Comments on submissions for Deadline 4

Applicants' response to ExAs 2nd Questions

Map, showing most of the proposed 13,000 acres + of solar development in the area, and the encirclement of my home by the fragmented and sprawling Cottam proposal.

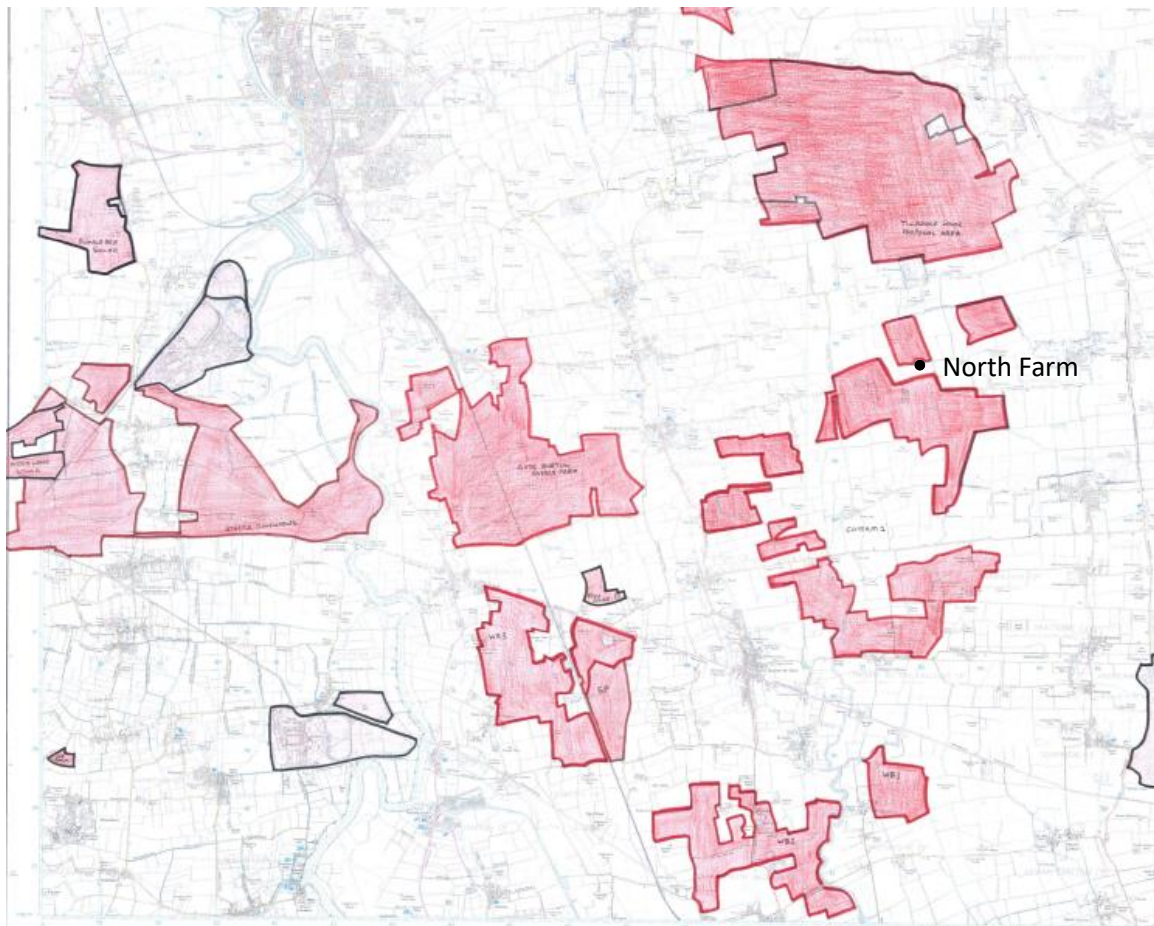
Firstly, it fails to show the "Steeple Renewables" proposal, which is now the fifth NSIP for the area and is just across the river from the Gate Burton Energy Park. (See map above) This fifth proposal should be added to the flyover for the ultimate benefit of the Secretary of State.

These 5 NSIPs all fall within a 10km/6-mile radius and cover a staggering 13,000 acres of farmland, with not one rooftop or brownfield site being used.
